**SYDNEY NORTH PLANNING PANEL
COUNCIL ASSESSMENT REPORT**

Panel Reference	2019SNH002
DA Number	DA2018/1752
LGA	Northern Beaches Council
Proposed Development	Demolition works and Construction of a Seniors Housing Development, comprising a Residential Care Facility and Independent Living Units, community and strata title subdivision
Street Address	Lot 368, DP 752017, No. 58 Laitoki Road, Terrey Hills
Applicant	Tolucy Pty Ltd
Owner	Barbara Enid Harris Anthony Brian Harris
Date of DA lodgement	26 October 2018
Number of Submissions	A total of 175 submissions received, which includes: <ul style="list-style-type: none"> • 174 individual submissions objecting to the proposal • 1 individual letter in support of the proposal
Recommendation	REFUSAL
Regional Development Criteria (Schedule 7 of the SEPP) State and Regional Development) 2011	Development with a Capital Investment Value (CIV) of more than \$30 million (\$69.6 million)
List of all relevant s4.15(1)(a) matters	<ul style="list-style-type: none"> • Environmental Planning and Assessment Act 1979; • Environmental Planning and Assessment Regulations 2000; • State Environmental Planning Policy (State and Regional Development) 2011; • Sta

Figure 2 - Proposed Building Arrangement

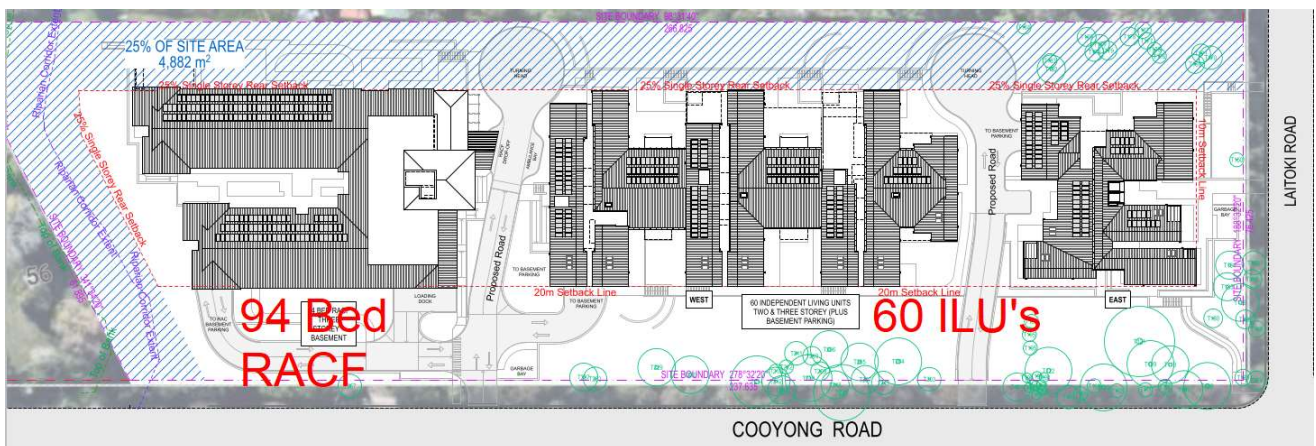
Further detail of the proposal is provided as follows:

Figure 3 – Proximity of Bus Stops to the Site

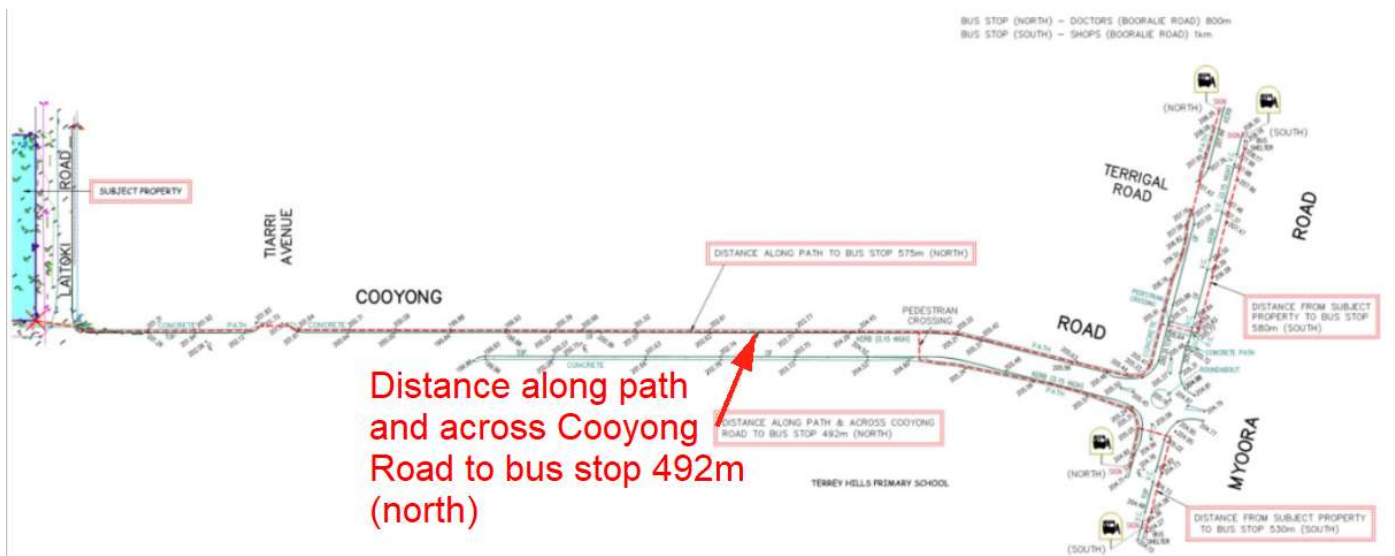
The site is not located within 400 metres of essential facilities and services and is substantially further than 400 metres from a public transport service (bus), being conservatively measured as 492 metres to 575 metres to the north bound bus stops on Cooyong Road from the south-east corner of the site. In addition, the grade of the road and road reserve does not satisfy the requirements of clause 26.

Figure 5 - East Elevation of the self-contained dwellings

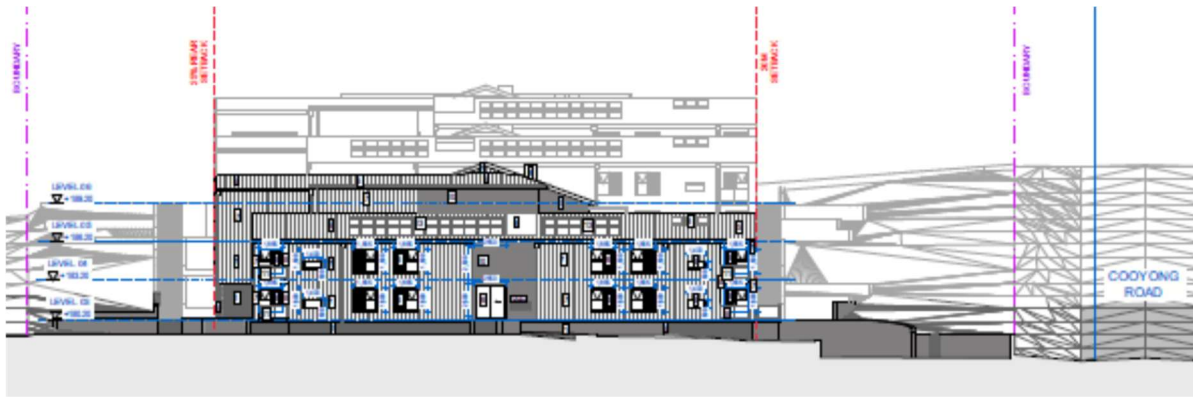
In this regard, the development is not regarded as a considered and sensitive response to the built form and scale of existing development.
